ALAMO
COLLEGES
DISTRICT

ADDENDUM VII (Final Addendum)

PURCHASE OF CONSTRUCTION SERVICES FOR SUNDANCE RENOVATION AT NORTHEAST LAKEVIEW COLLEGE RFP 2026-0080

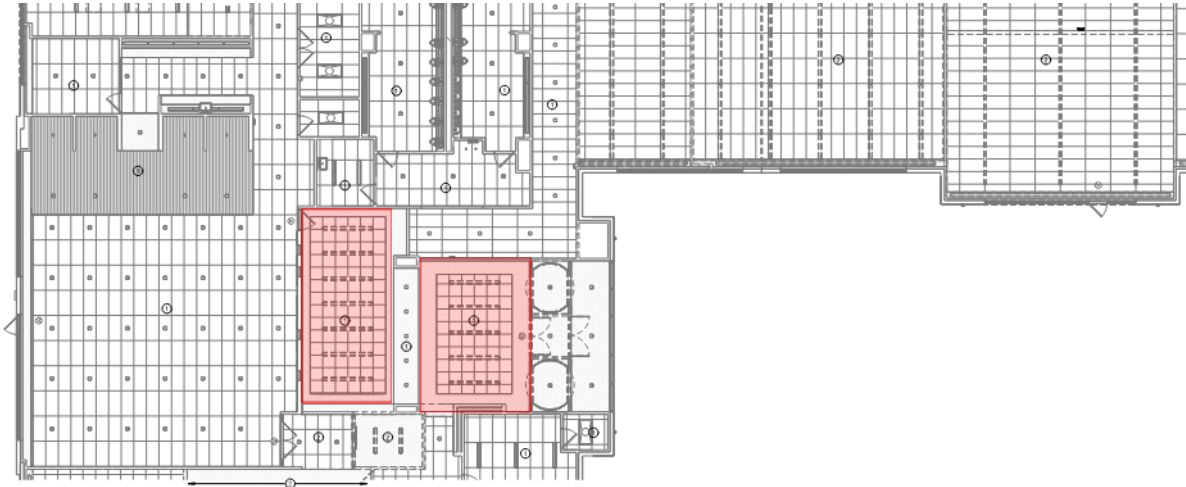
XII.**Question:** Sheet ES-101 contains Site Plan Keyed Note #7. The plans do not show this note designated anywhere. Please advise where note #7 applies.

Answer: Based on landscape's drawings, irrigation drawings will be submitted by the contractor. With this being said keynote 7 will be change to a general note for the new irrigation controller to use power from the existing irrigation controller and if a new location is provide then the contractor shall pull power from the nearest available panel.

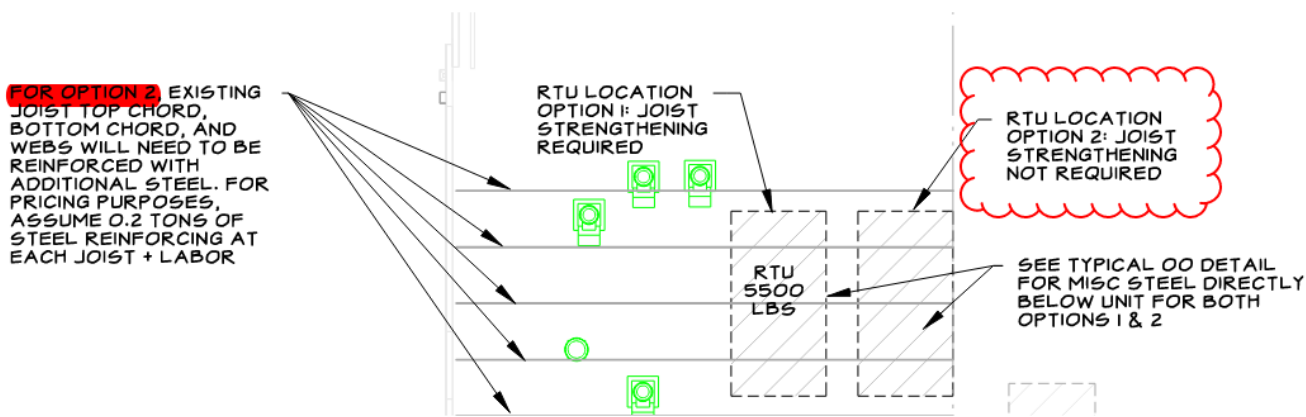
XIX.Question: Roof Area B: CU-1B and CU-2B, do these new CU need a conduit penetration for each unit or 1 penetration to accommodate the two CU? or will they reuse a nearby penetration?

Answer: Coordinate with electrical discipline. Typically, one shared penetration with proper sealing is acceptable. For refrigerant piping a hooded curb is ideal, refer to Mechanical detail 13/M-301 "Hooded Curb Detail".
